INDEX SHEET FOR SOURCE MATERIAL LICENSE AMENDMENTS OR REVISIONS

Page 1 of 6  
 Date: 8-13-2008  
 Docket No. 040-09067  
 LICENSE NO.: \_\_\_\_\_

MINE COMPANY NAME: Uranerz Energy Corporation  
 MINE NAME: Nichols Ranch ISR Project

**FIGURE D1-2**  
**LAND USE AND NEAREST RESIDENT LOCATIONS**

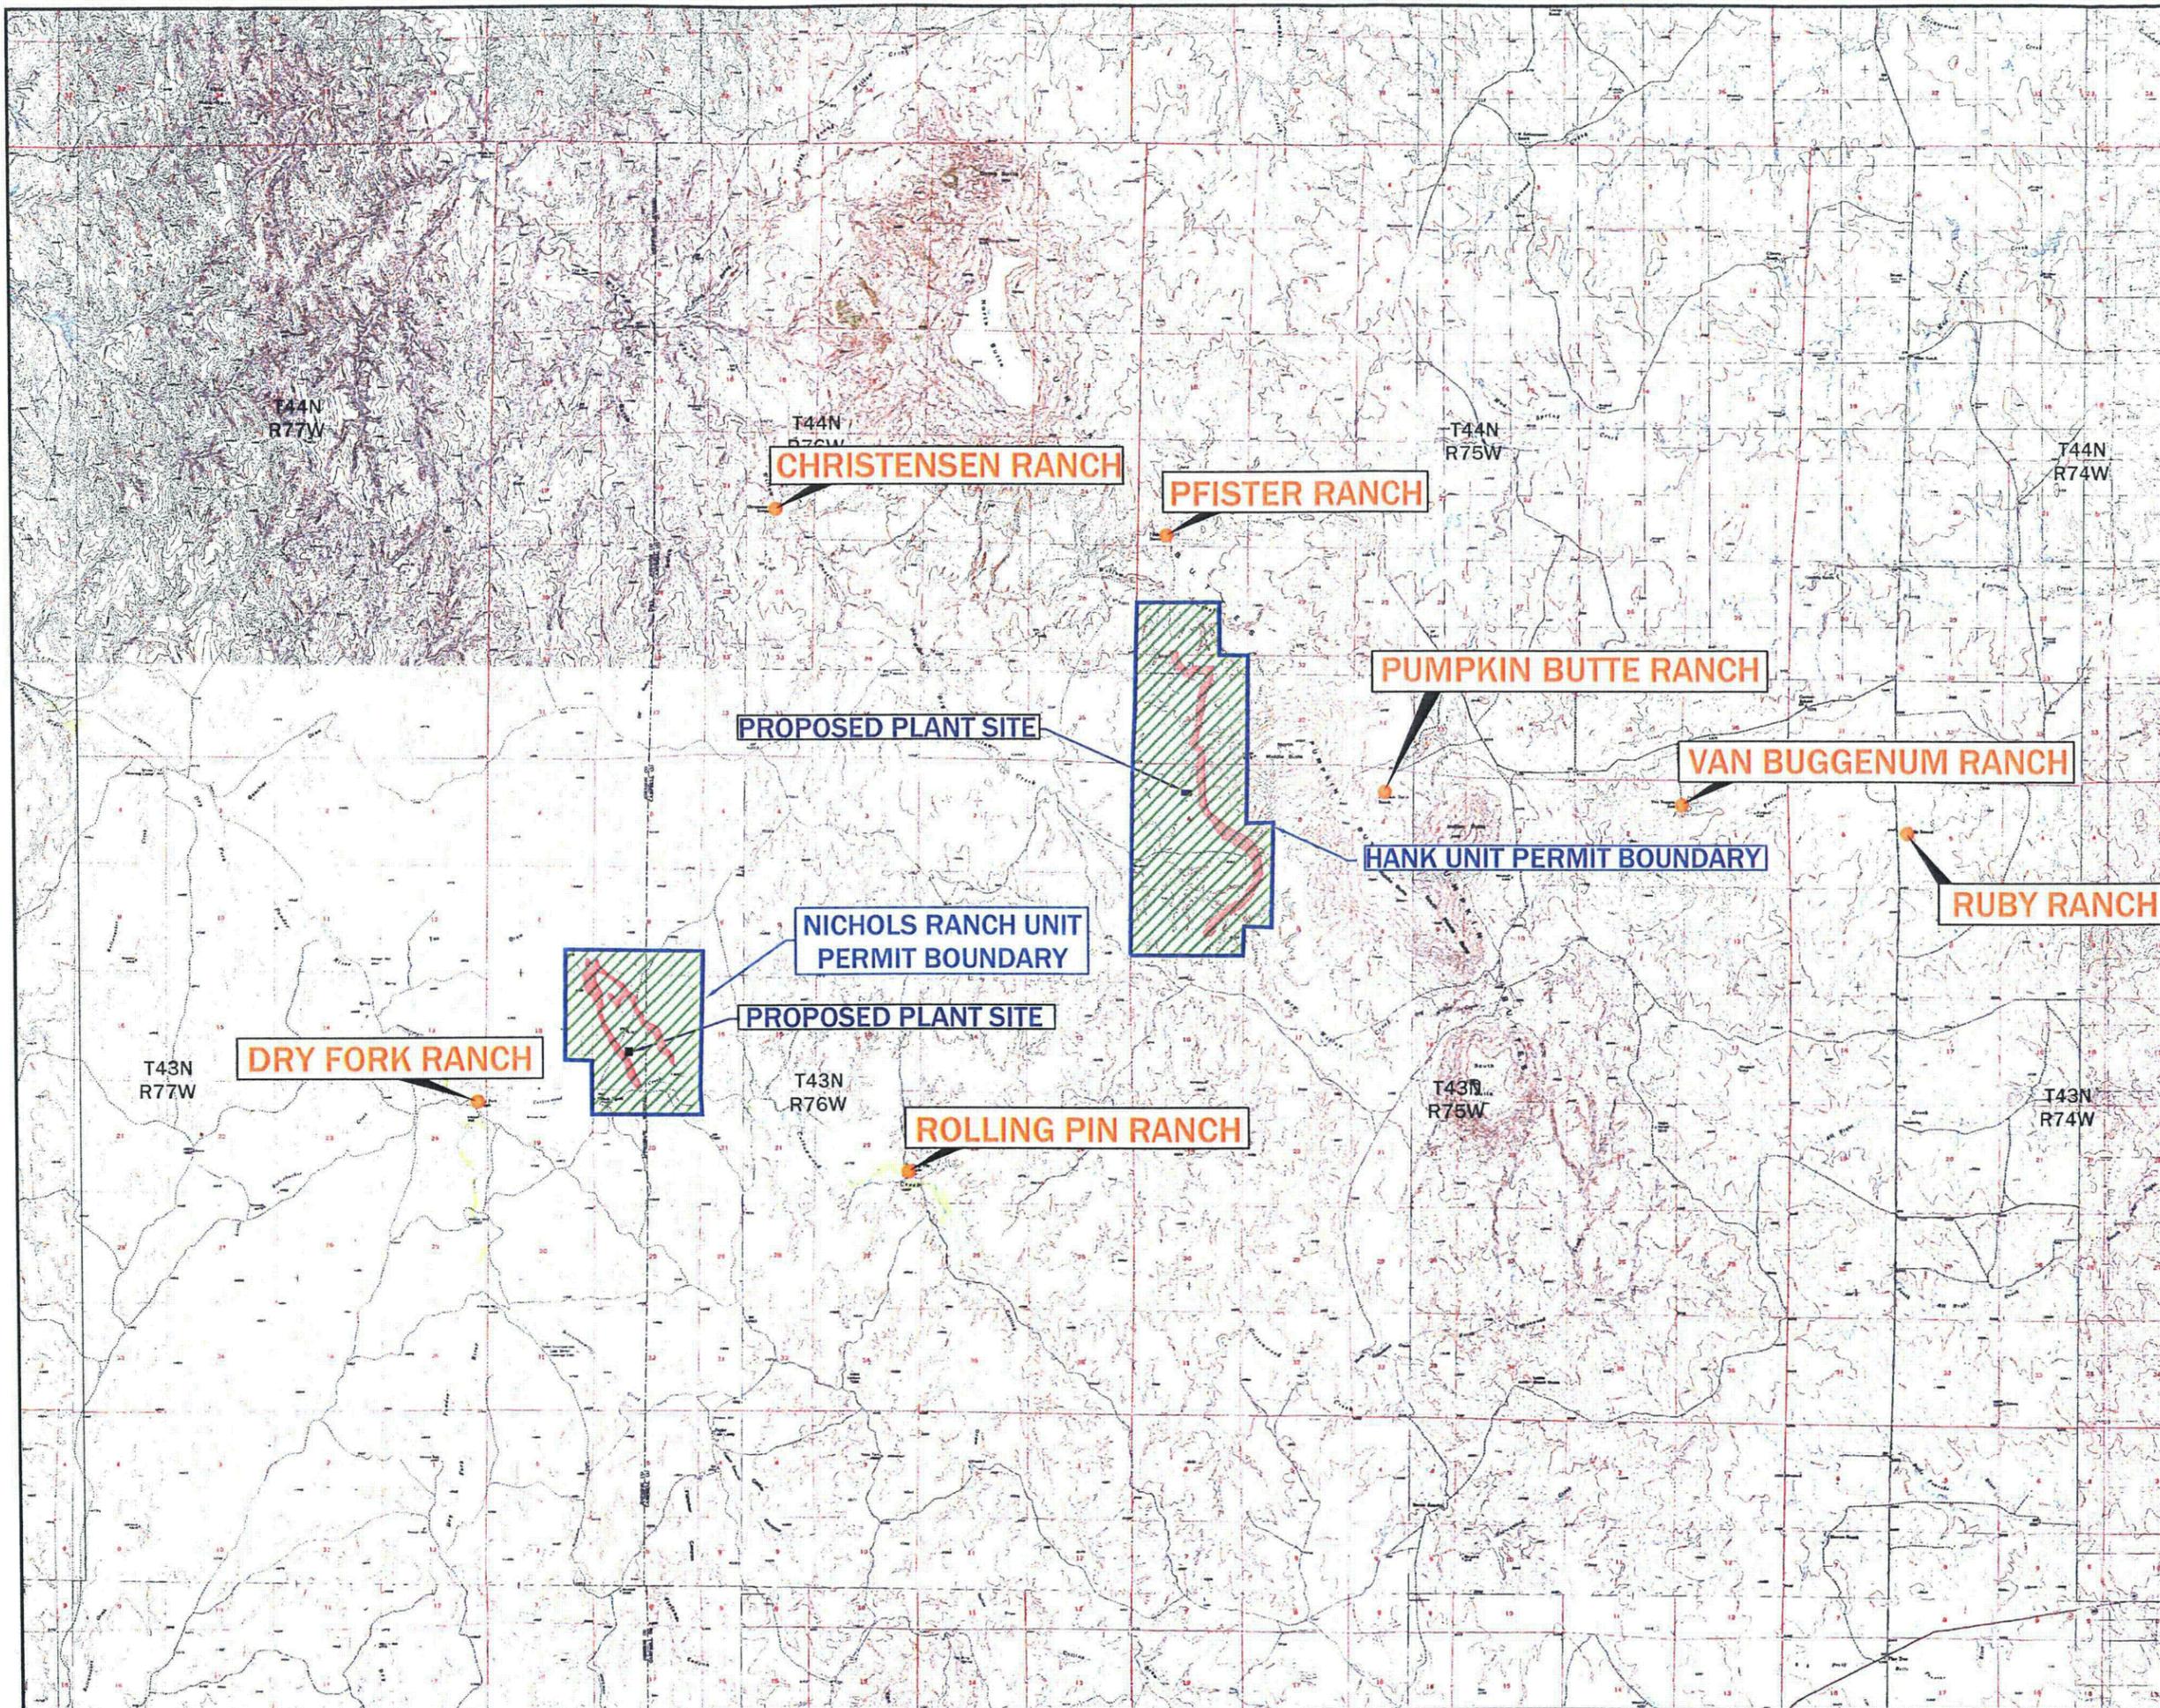
<u>IV, Appendix D1</u>	<u>Pages D1-3 and D1-4</u>	<u>Pages D1-3 and D1-4, March 08</u>	<u>Pages revised to include Figure D1-1 and some minor text changes</u>
<u>IV, Appendix D1</u>	<u>Figure D1-2, Map Pocket</u>	<u>Figure D1-2, March 08 (Map Pocket)</u>	<u>Replaced figure and revised to include past and current land use.</u>
_____	_____	_____	_____
_____	_____	_____	_____
_____	_____	_____	_____
